ARCHITECT'S ADDENDUM

Addendum Number: 003

RE: EASD #131 East Aurora High School
2027 Mechanical Improvements

Subject: Addendum No. 003 to the Construction Documents for the EASD #131 East Aurora High School 2027 Mechanical Improvements Project.

DRAWING TITLE:
ROOF MECHANICAL
PLAN - AREA D

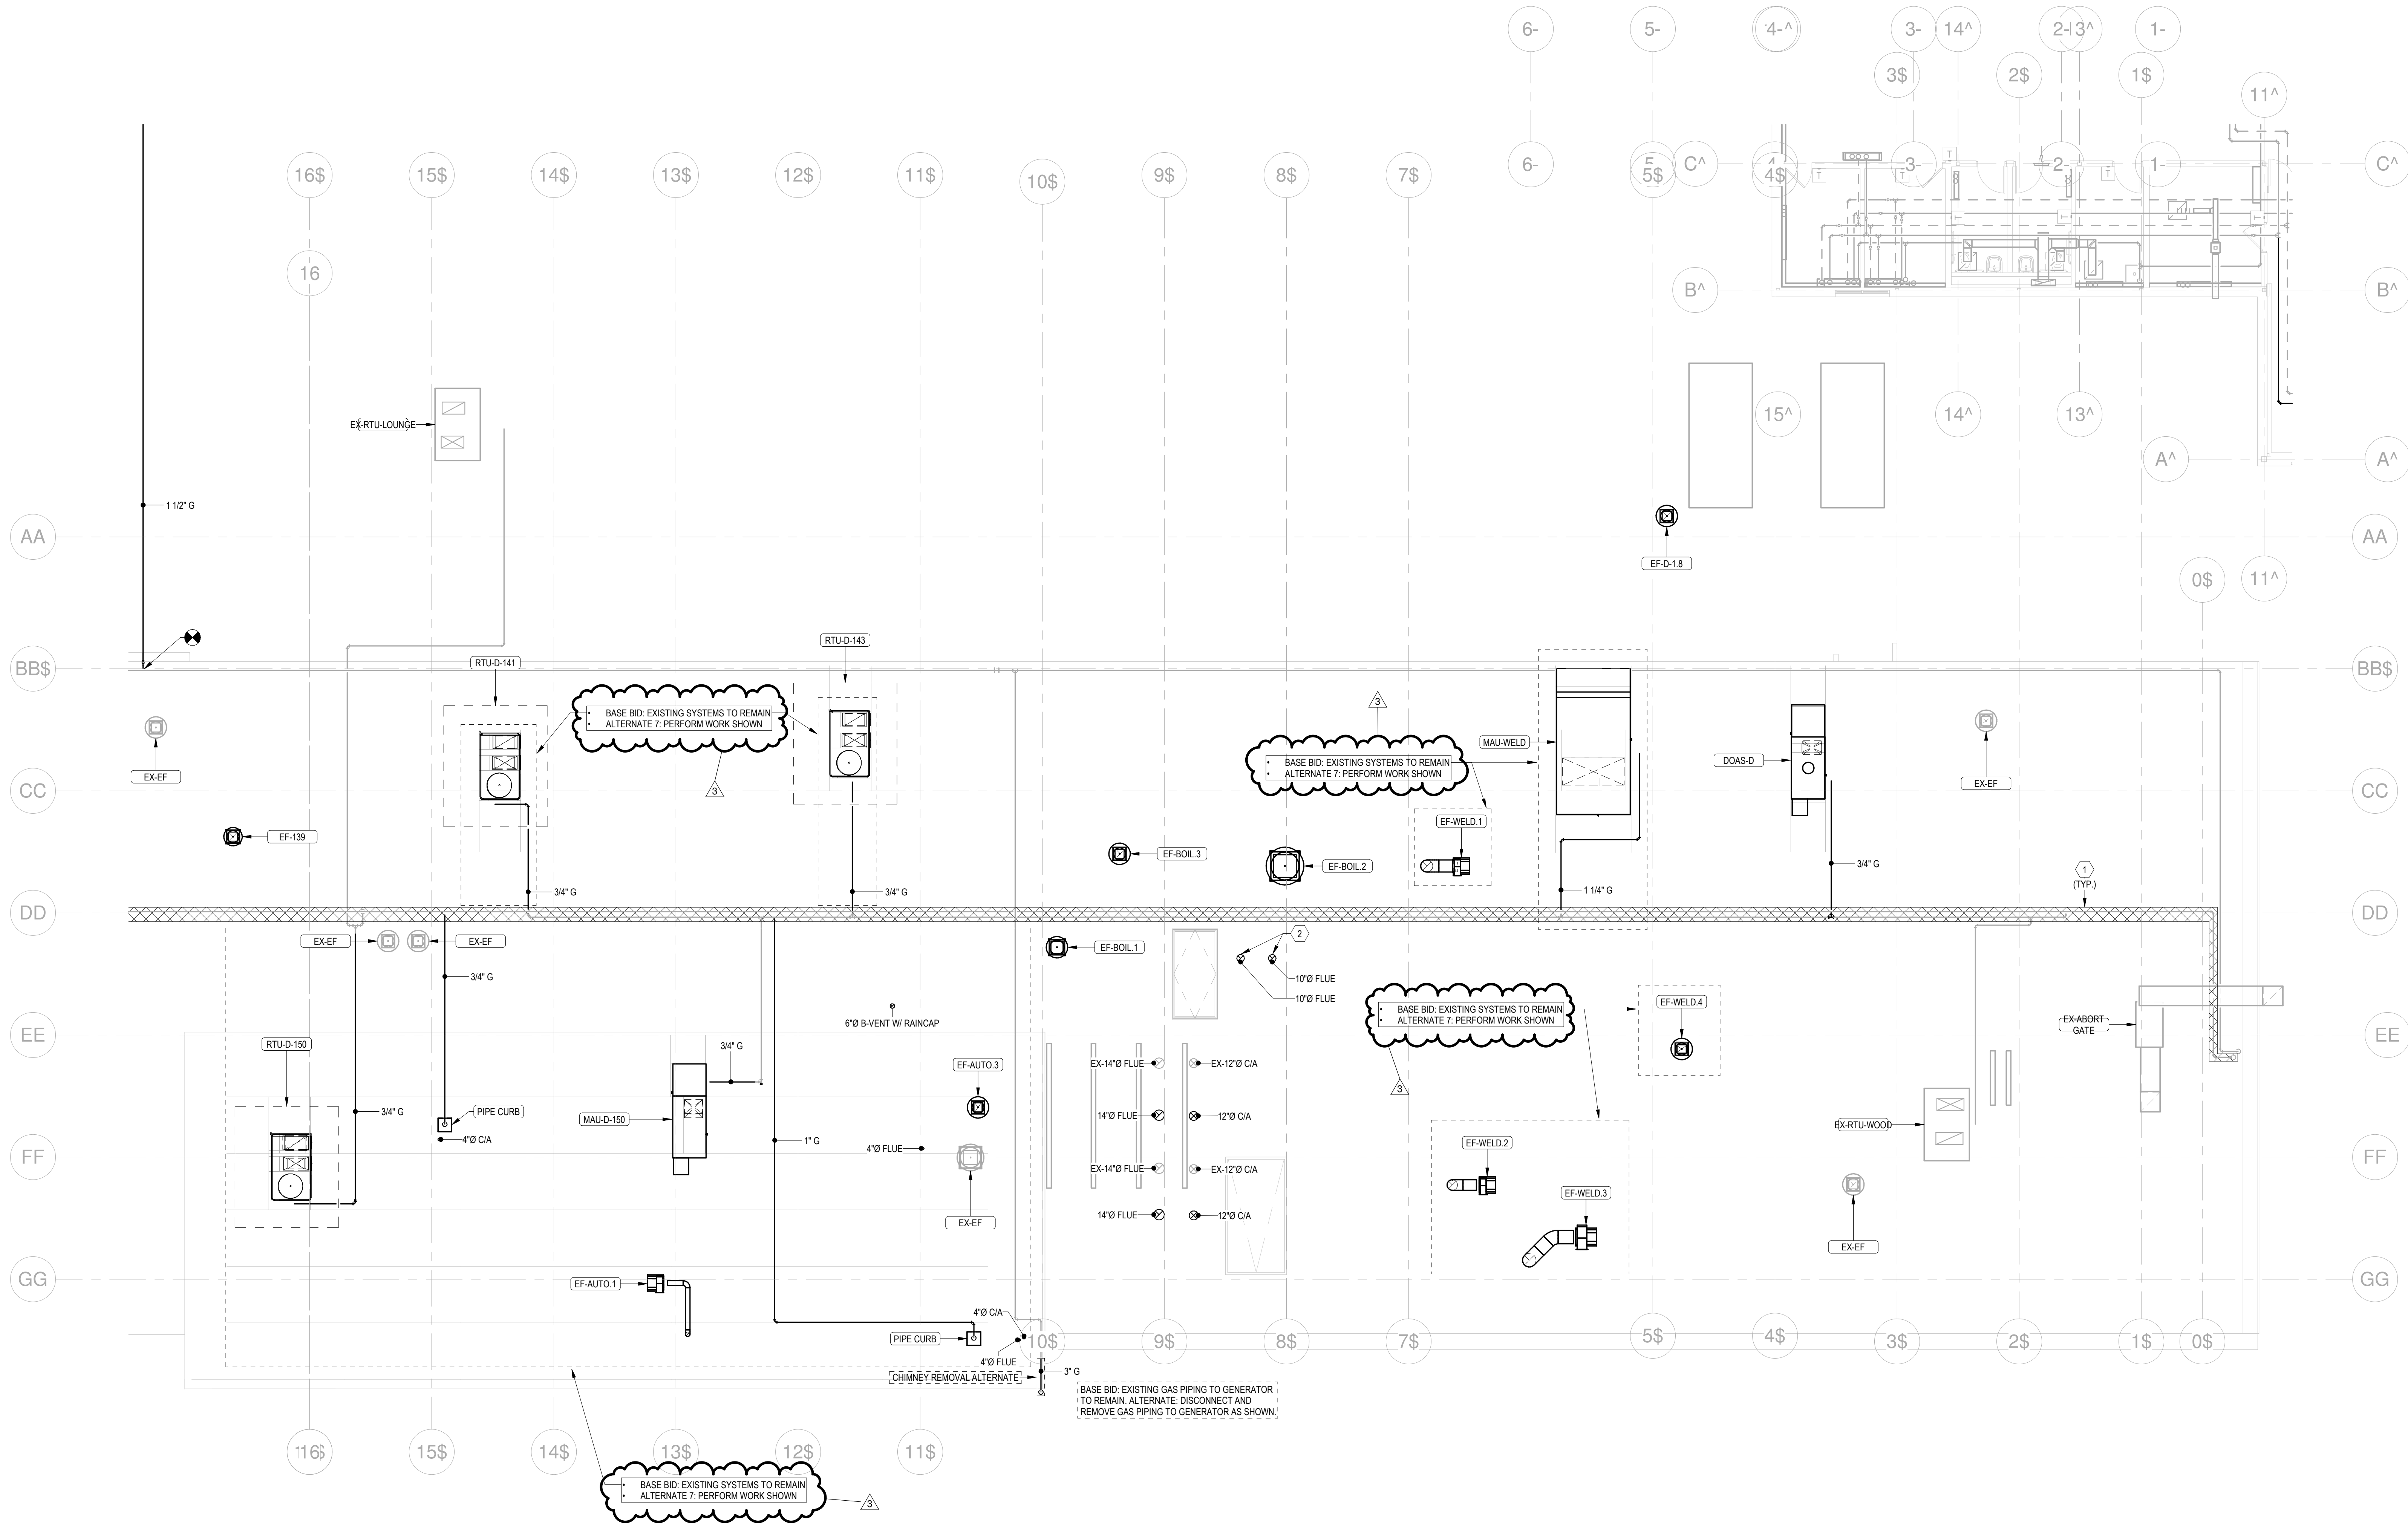
5. D-M2.2 – ROOF MECHANICAL PLAN – AREA D
 - **ADDED** boundaries indicating work that was formerly part of the Base Bid is now part of Alternate #07. Refer to attached sheets for further information.

4 AREA D - PARTIAL ROOF FRAMING PLAN
1/8" = 1'-0"

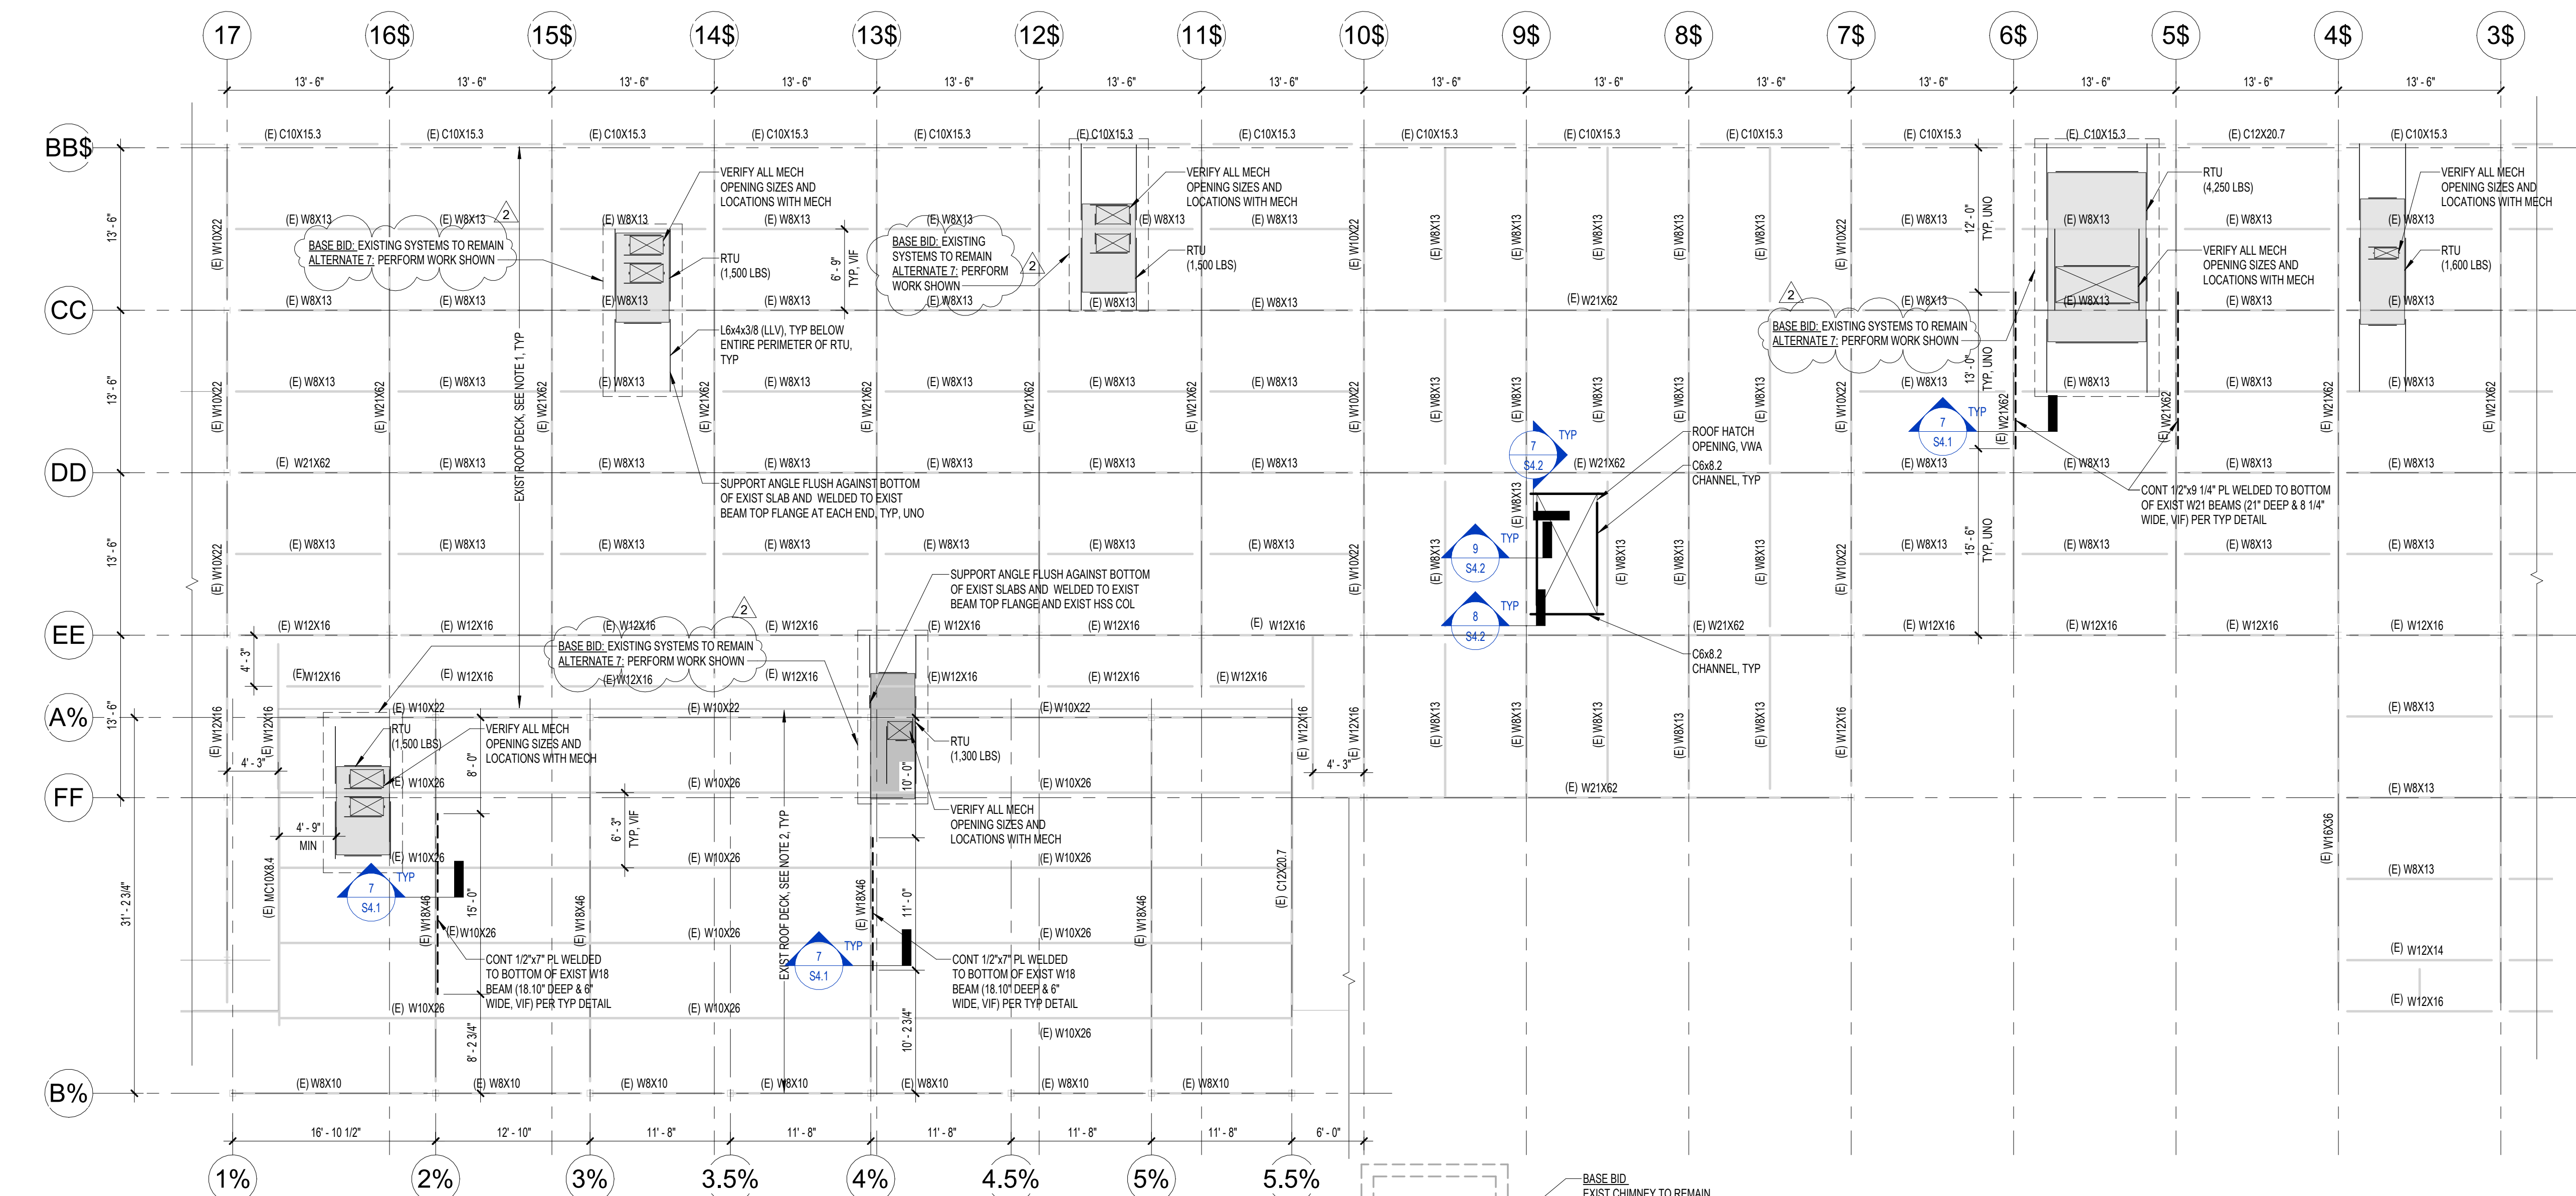
8. S2.2 – PARTIAL PLANS – AREA D
 - **REVISED** drawing notes on 4/S2.2 – Partial Roof Framing Plan to indicate Base Bid and Alternate #07 Work.

1 AREA G - PARTIAL ROOF FRAMING PLAN
1/8" = 1'-0"

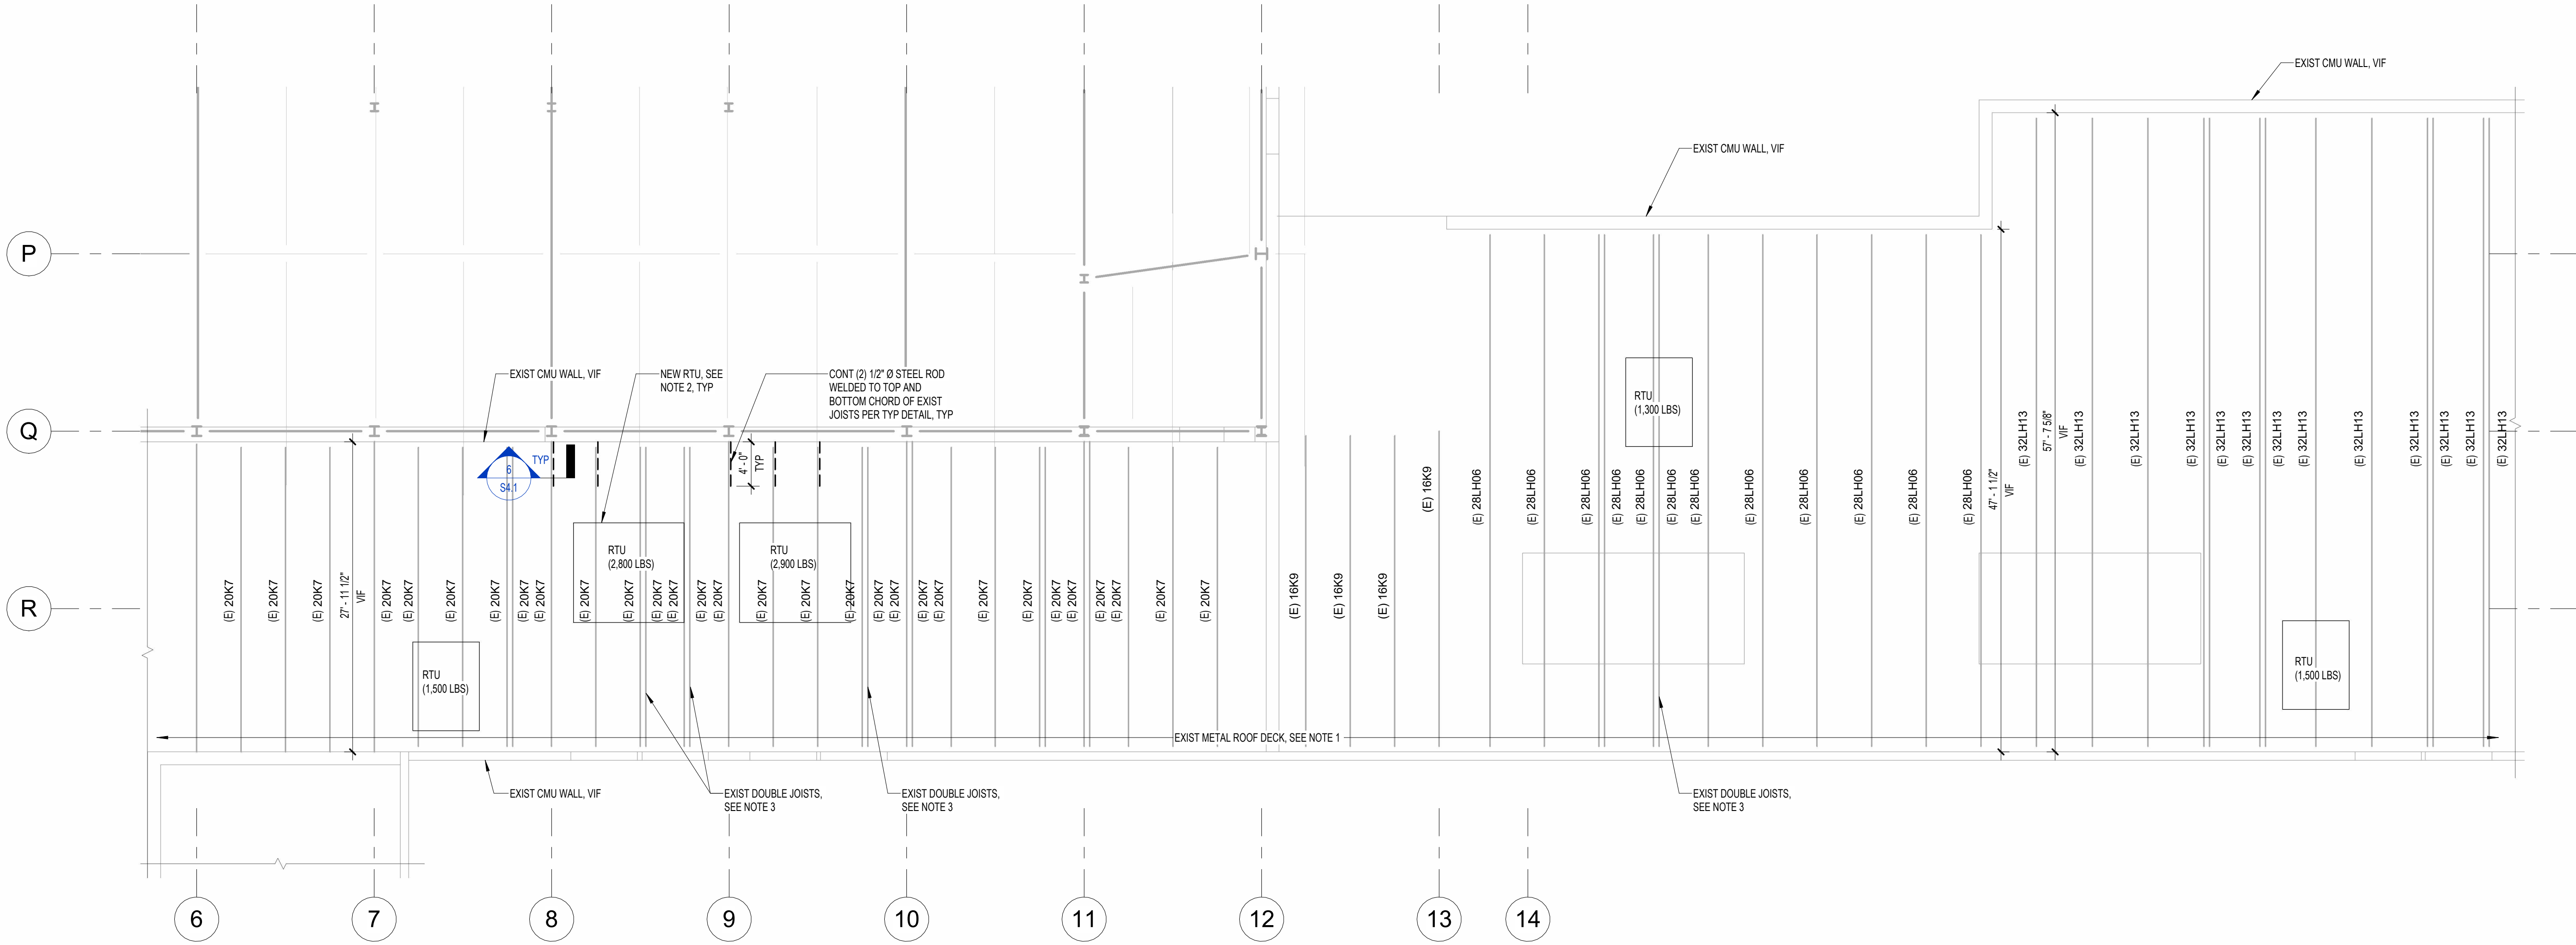
9. S2.3 – PARTIAL ROOF FRAMING PLAN – AREA G

- **ADDED** new sheet to show structure work needed for the new RTUs on the existing roof of Area G per Alternate #02.
